Field Campaign on 8.2 Inboard ECT Engines

Inboard Models	Serial Number
8.2 Horizon DTS ECT	1A350802-1A353889
8.2 H.O. DTS ECT

Mercury Marine has determined that some 8.2 Inboard Emission Control engine models within the Models Affected serial number range may experience a hydraulic lock after hard running conditions and keying off. This situation may prevent the engine from restarting and could damage internal engine components.

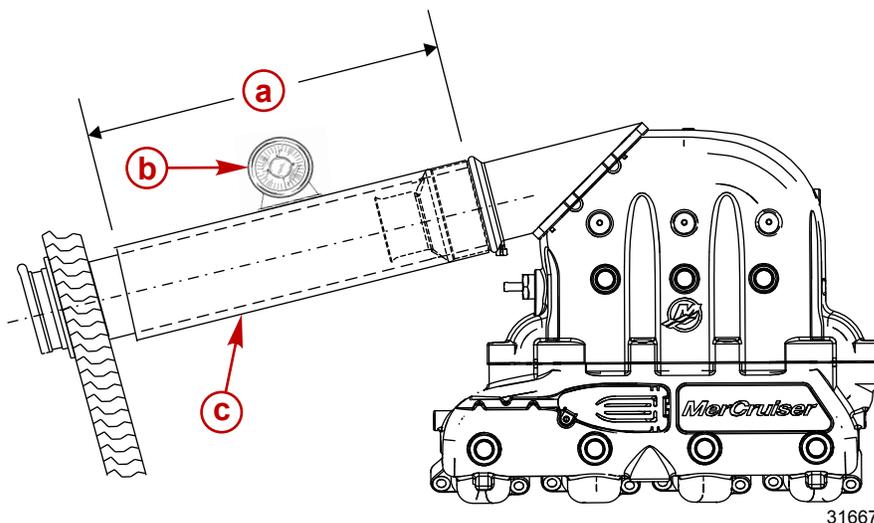
Exhaust elbow replacements, diverter tube, and vent valve installations must be performed to prevent hydraulic lock.

NOTE: Measure the marine grade exhaust tubing aft of the elbow to ensure the minimum distance of 457 mm (18 in.). If this dimension is below the specification contact your boatbuilder.

- a - Minimum 457 mm (18 in.)
- b - Inclinometer
- c - Exhaust hose or tube

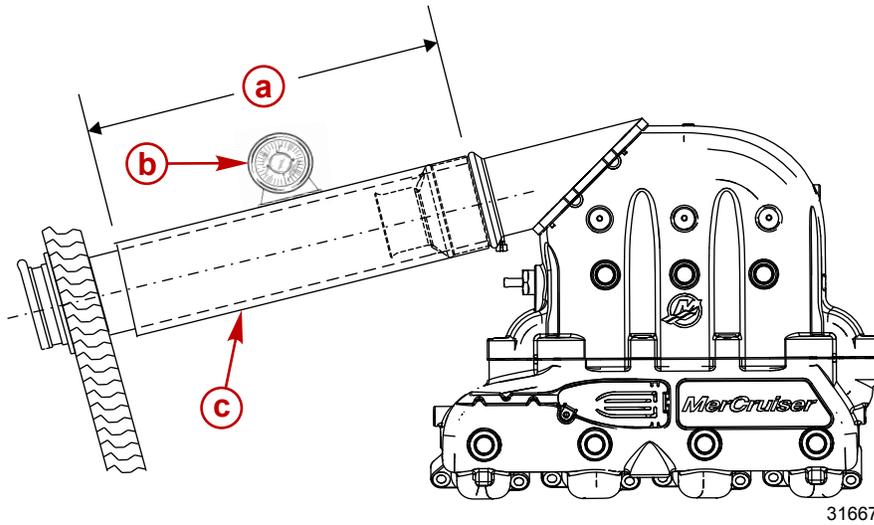
IMPORTANT: MerCruiser specifies a minimum distance of 457 mm (18 in.) from the exhaust elbow to the exhaust hose.

NOTE: Measure the marine grade exhaust tubing aft of the elbow to ensure the minimum distance of 457 mm (18 in.). If this dimension is below the specification contact your boatbuilder.

- a - Minimum 457 mm (18 in.)
- b - Inclinometer
- c - Exhaust hose or tube

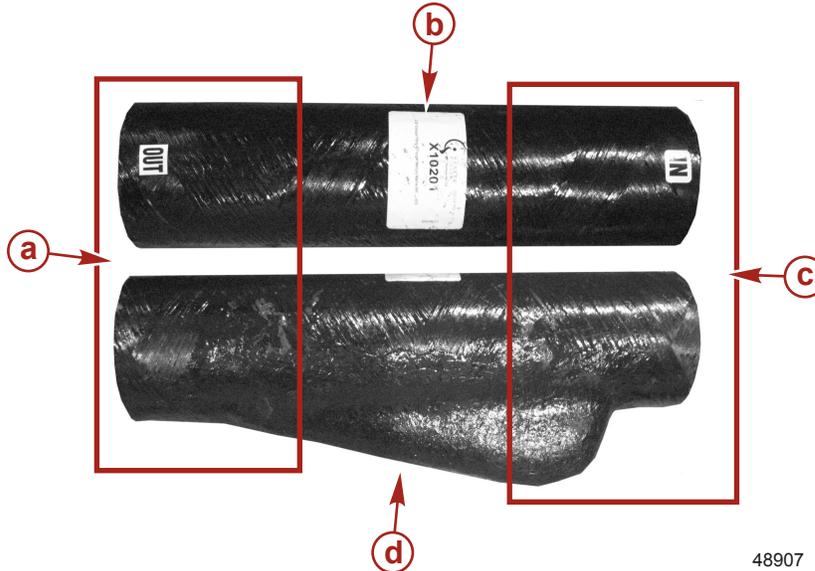
IMPORTANT: To function properly, the end of the tube marked "IN" is positioned toward the engine exhaust elbow with the deepest portion of the diverter tube facing straight down. Do not cut or modify the diverter tube.

- a - End of diverter tube marked "OUT"
- b - Top view of diverter tube
- c - End of diverter tube marked "IN"
- d - Side view of diverter tube

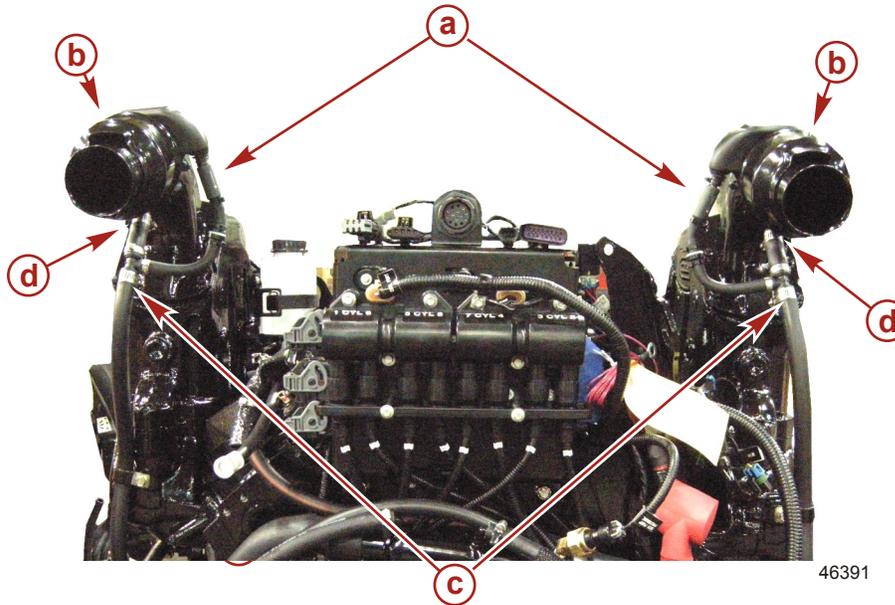
Install a vent valve assembly on the port and starboard exhaust elbows of the engine. The vent valve assemblies will prevent a vacuum from occurring in the exhaust system when the key is turned to the off position.

10. Tighten the worm-gear hose clamp to specification at the T-fitting and the water fitting on the exhaust elbow.

- a - Duckbill valve
- b - Reservoir weep hole
- c - Worm-gear hose clamp at T-fitting
- d - Worm-gear hose clamp at the water fitting

Description	Nm	lb-in.	lb-ft
Worm-gear hose clamp	4	35	-

Reposition and Torque the Flame Arrestor Clamp

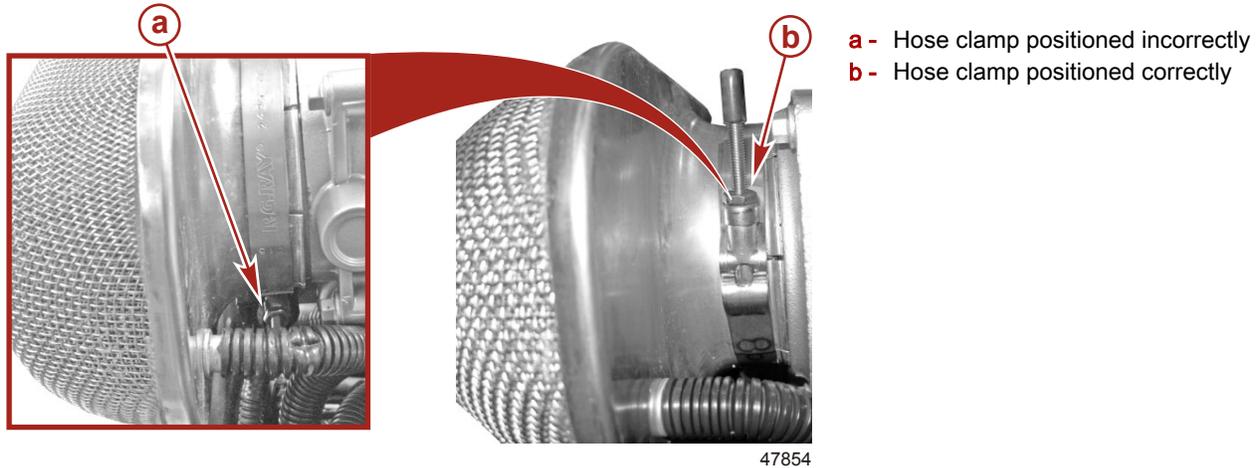
Mercury Marine has also determined that the flame arrestor clamp may be incorrectly positioned. The flame arrestor clamp must be positioned correctly and tightened to specification.

Inspecting, repositioning, and tightening the flame arrestor's clamp to specification eliminates possible differences in the torque value applied to the clamp.

- Loosen the hose clamp on the flame arrestor.
- Move the hose clamp to an easily accessible position as shown.
- Hold the flame arrestor in position on the throttle body with the hose clamp completely around the flame arrestor and throttle body.
- Tighten the hose clamp to specification.

Description	Nm	lb-in.	lb-ft
Flame arrestor hose clamp	6	55	–
